TMI-14-123

Three Mile Island Nuclear Station, Unit 1
Renewed Facility Operating License No. DPR-50
NRC Docket No. 50-289

Subject: License Amendment Request - Modify Reactor Coolant System Pressure Isolation Check Valve Technical Specification Maximum Allowable Leakage Limits

SUBJECT: Modify Reactor Coolant System Pressure Isolation Check Valve Technical Specification Maximum Allowable Leakage Limits

SIMPLIFIED SCHEMATIC DIAGRAM OF EMERGENCY CORE COOLING SYSTEMS

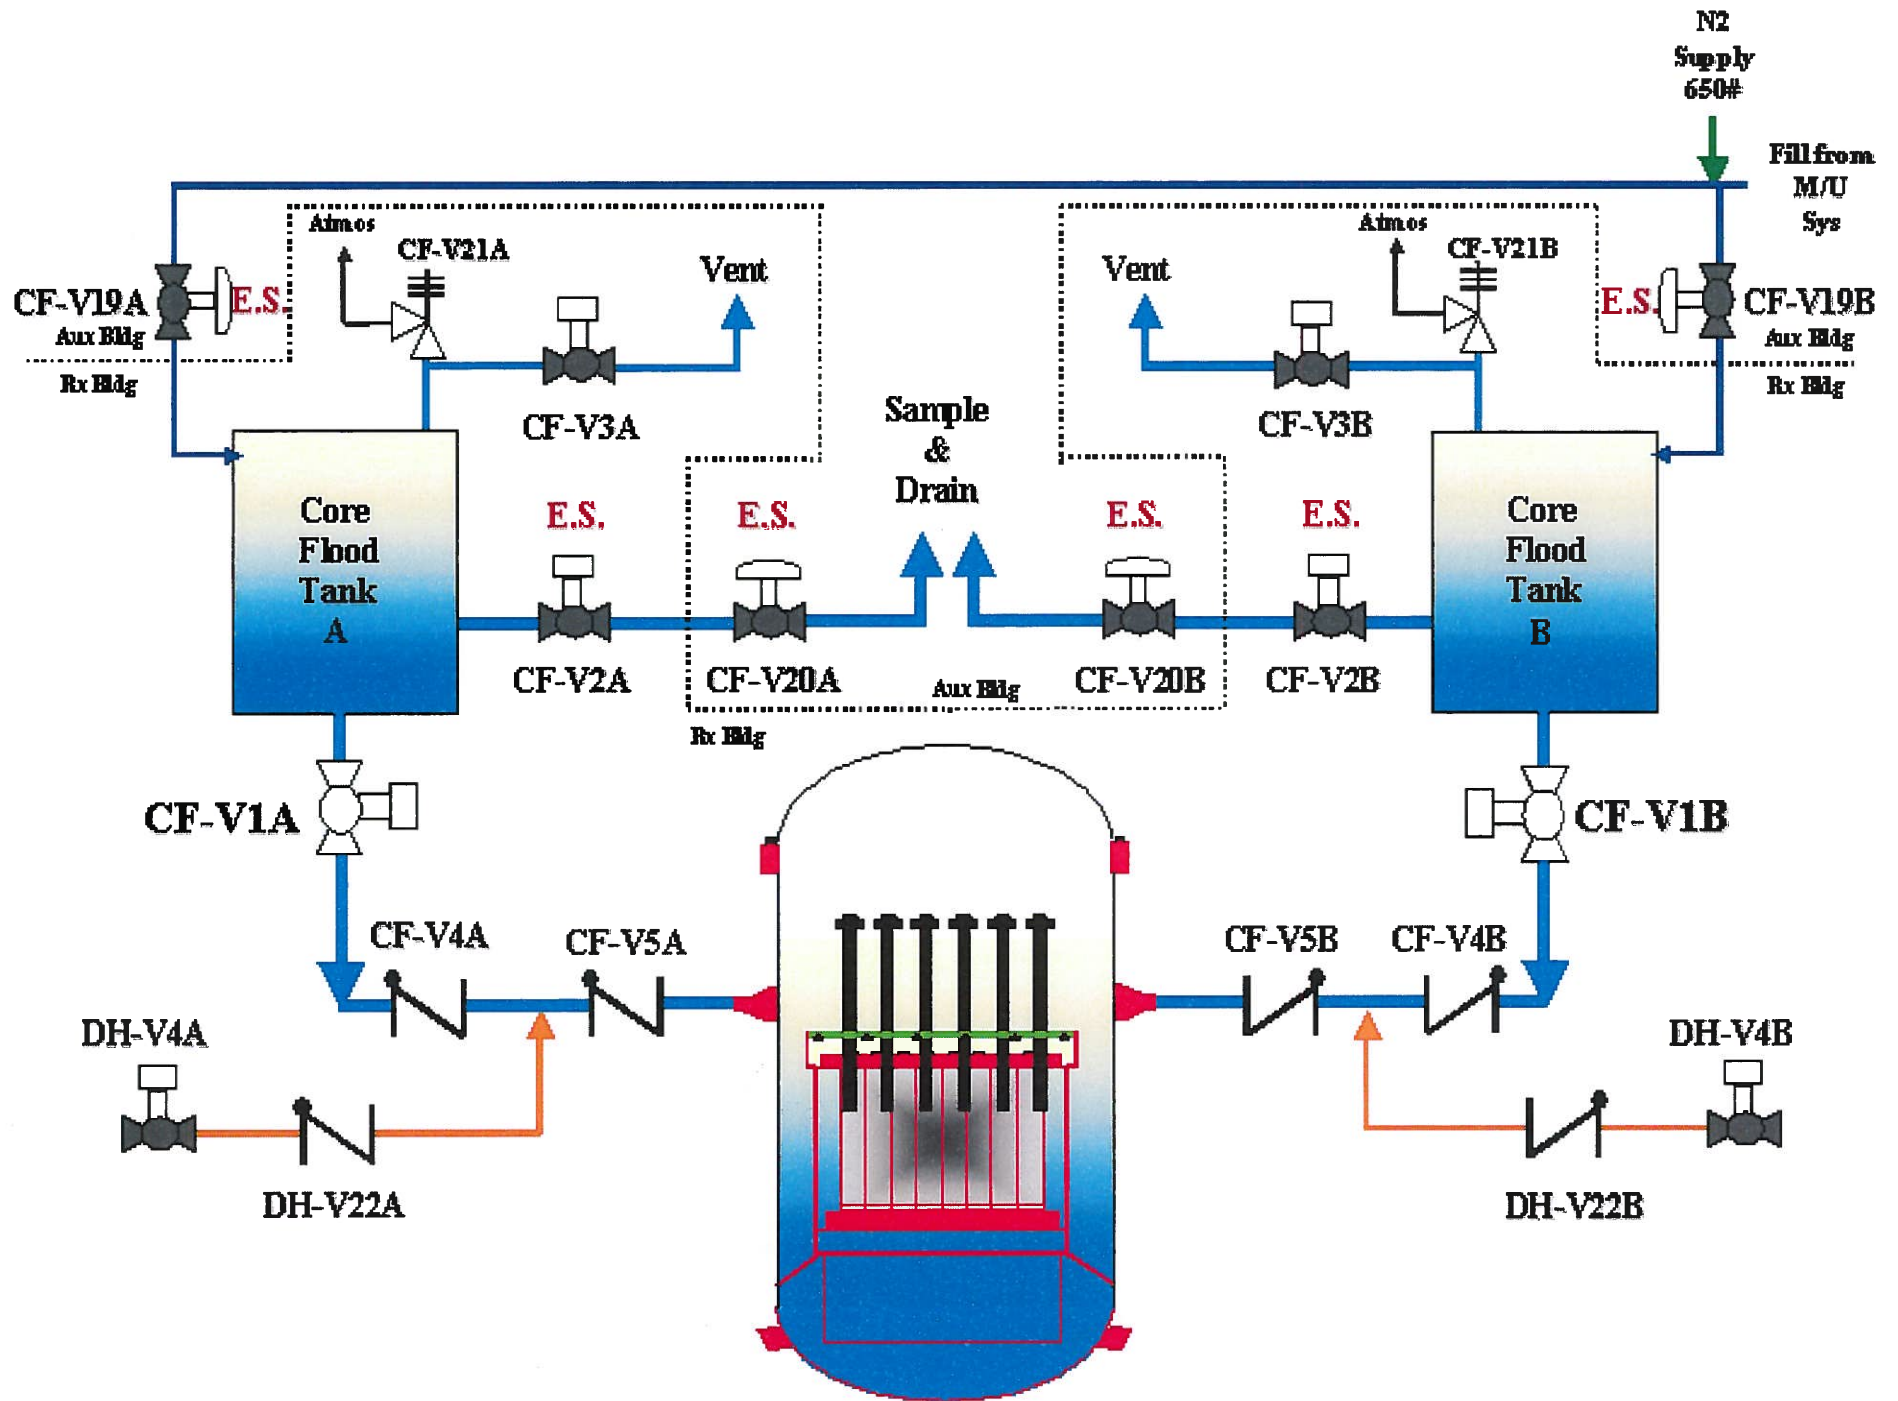
RCS PIVs (CF-V5A, B and DH-V22 A, B) are those check valves in the primary RCS that isolate the boundary between the high pressure primary coolant system and connected low pressure piping systems. These valves are included in a Simplified Schematic Diagram of Emergency Core Cooling Systems (see Attachment 3).

CF-V-5A Through Leakage

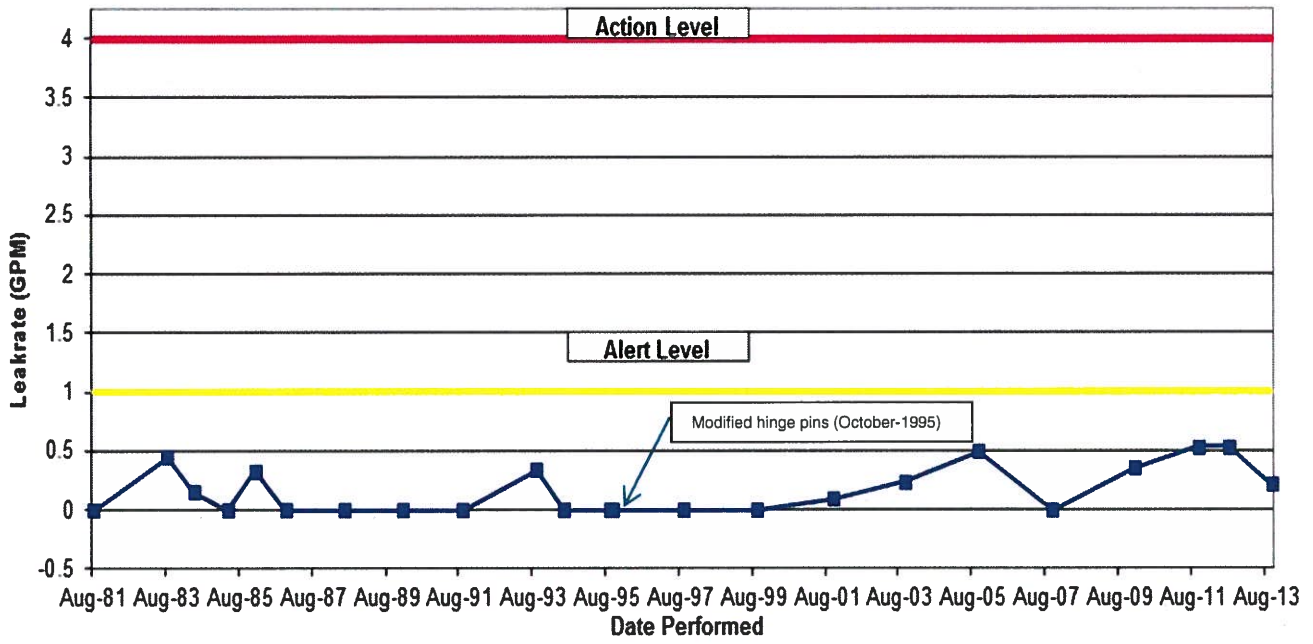
- CF-V5A has maintained a leak rate generally below approximately 0.5 gpm since August 1981.
- CF-V5B has been found to have leakage. It most recently underwent seat repair in 2003, but its leakage has increased over the last few outage tests to approximately 2.6 gpm. The current trend has been identified and being tracked in the Corrective Action Program.
- DH-V22A/B have had no measureable leakage since 1999, except in 2010, when each valve was found with less than 1 gpm. The step increase in 2007 on the chart results from adding a conservatism to the test result to account for uncertainty due to the volume of the test tubing when there is no measureable leakage. Thus, the 0.68 gpm value is a bounding value representing only the maximum possible leakage rate for each of these valves.

Since the valves are paired in series, CF-V5A and DH-V22A protect the "A" train of LPI, and CF-V5B and DH-V22B protect the "B" train of LPI. The actual leakage from the RCS will be based on the tighter of the two valves in series. Thus, based on IST leakage testing, it is currently < 0.22 gpm for one train and < 0.68 gpm for the other train.

DH PIV Leakage
(T.S. limit is the lesser of 5 gpm or halfway from last test to 5 gpm)

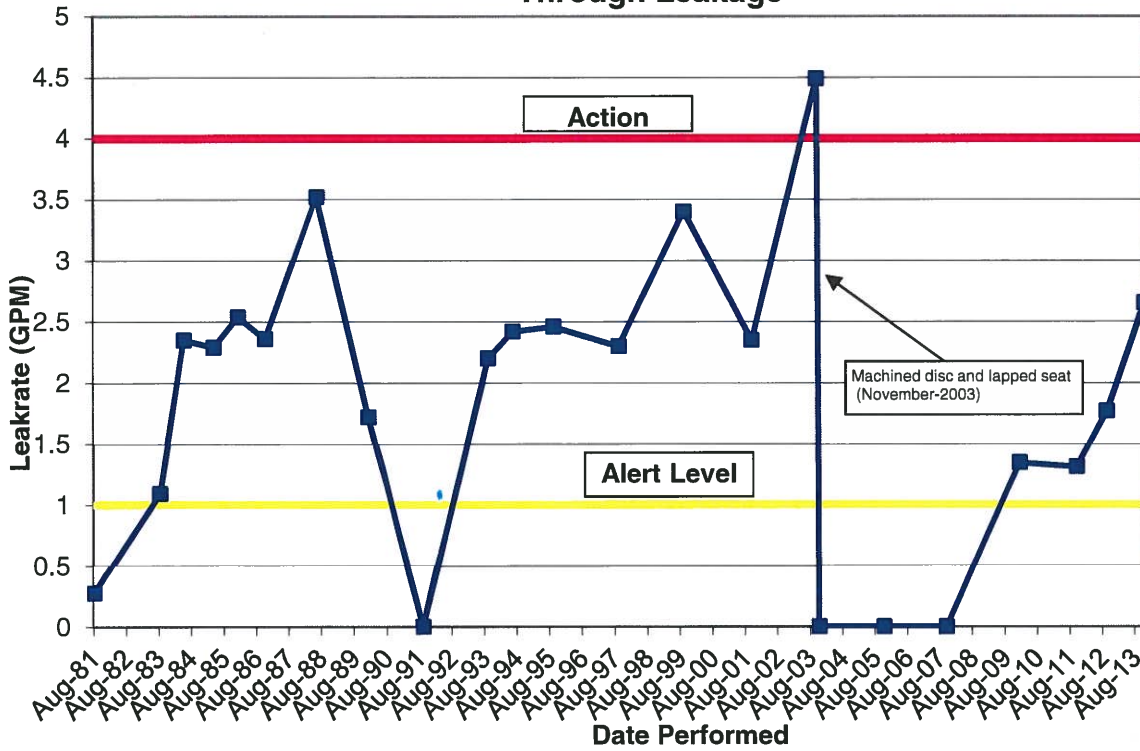
The history of the leakage results from the outage testing and maintenance of the RCS PIVs is provided in Attachment 4. As allowed by the TS, these tests are performed at reduced RCS pressure, with at least 150 psi pressure differential across each of the valves. The leakage results are adjusted up to the maximum accident pressure differential across each of the valves as described in the ASME OM Code, which applies a multiplier that is the square root of the pressure differential ratio. This adjustment is conservative in that it does not recognize that the valves may seat tighter at higher differential pressures. A brief summary of the trends is provided below:
